**ADDENDUM NO. ONE (1)
TOWN OF BRASELTON, GEORGIA
NEW LAB AND CONTROL BUILDING
ISSUED SEPTEMBER 20, 2016**

RE: NEW LAB AND CONTROL BUILDING
PROJECT 10-002
Braselton, Georgia

FROM: ENGINEERING MANAGEMENT, INC.
303 SWANSON DRIVE
LAWRENCEVILLE, GA 30046
Don Baker, P.E.
770-962-1387

Note: Clarion showers, Sheet P1 above, grab bars are included Clarion Model indicated.

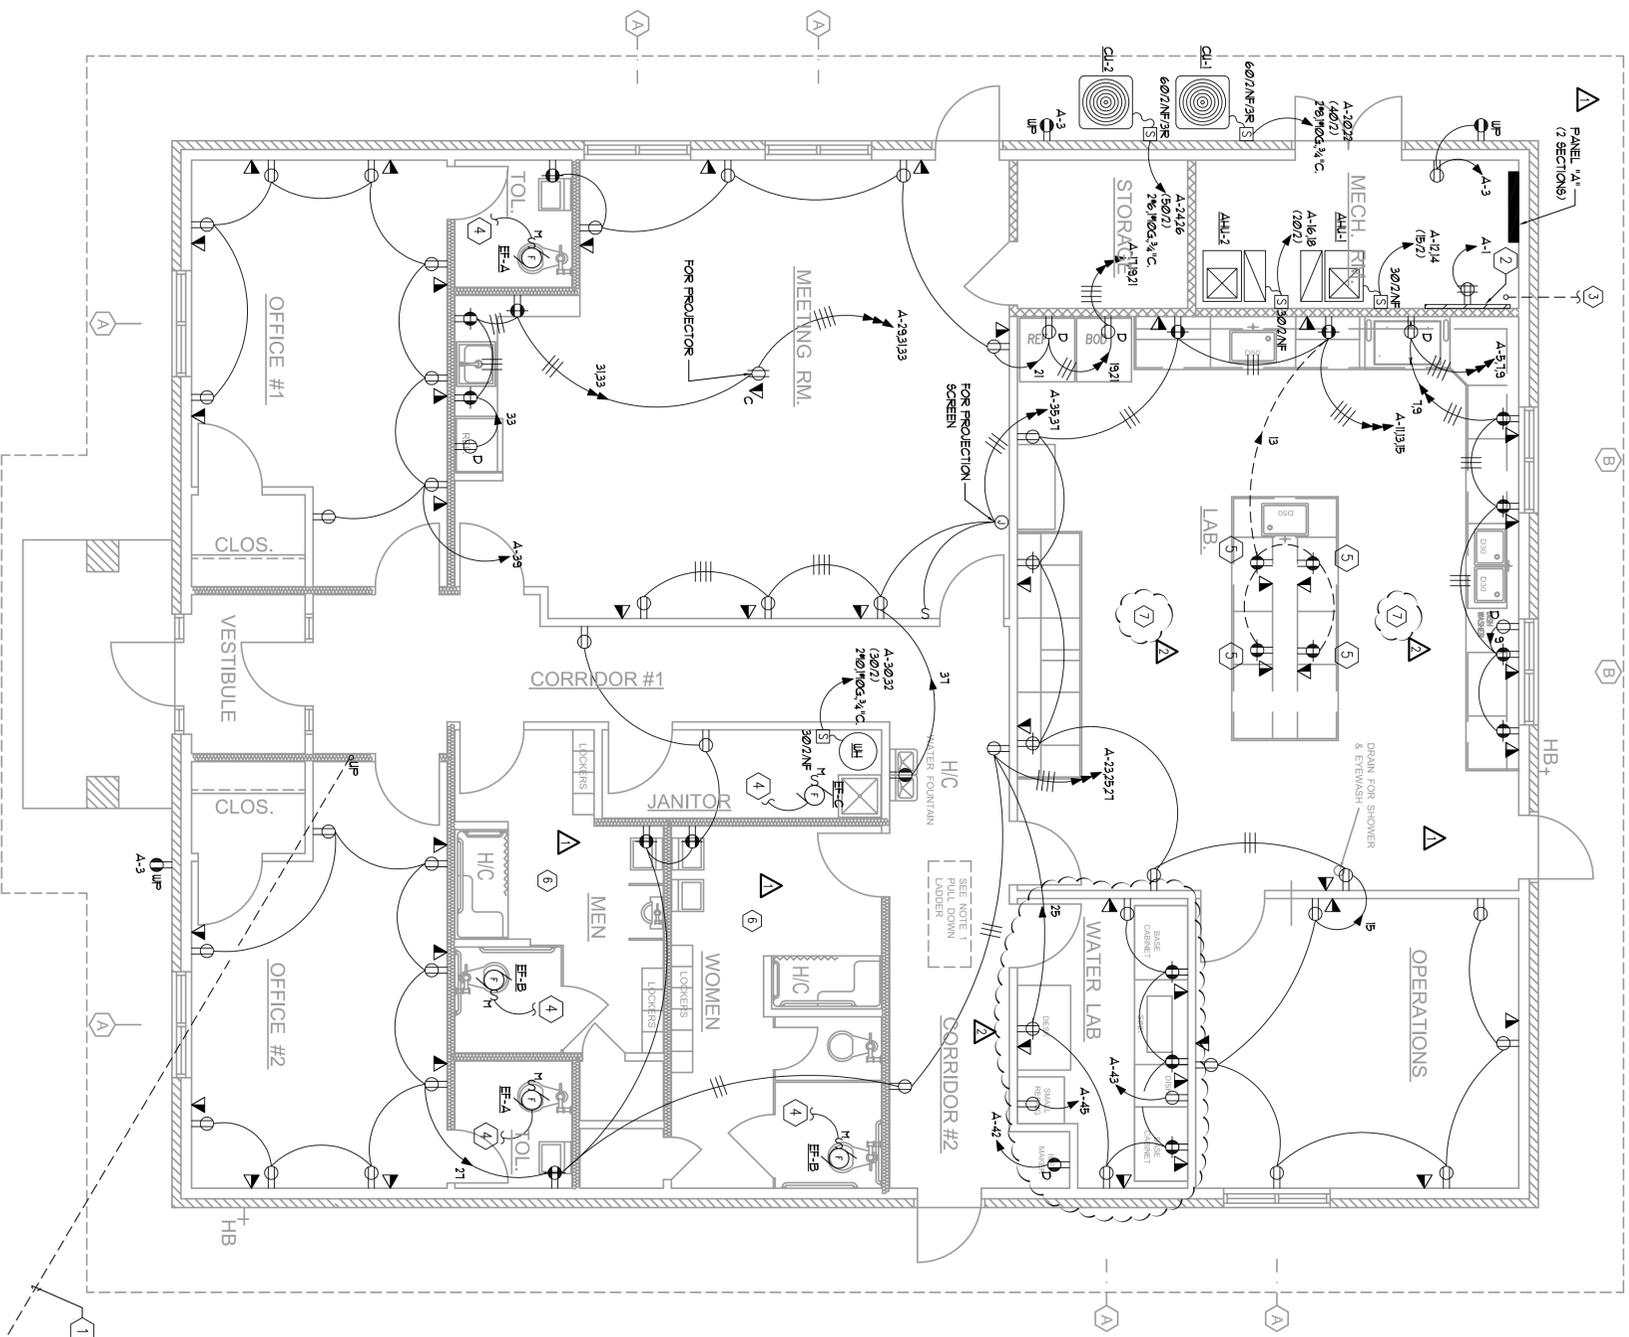
Sheet P1 – Question: What are the specifications for the two shower stalls shown on Sheet P1.

Response: The shower for each restroom shall be a Clarion MP6030BF (60”x30”) ADA shower with grab bars and seat. The Shower Valve shall be Delta R1000-UNWS. Shower Head shall be Delta T13H152 trim with 1.5 GPM shower head on 24” ADA adjustable slide.
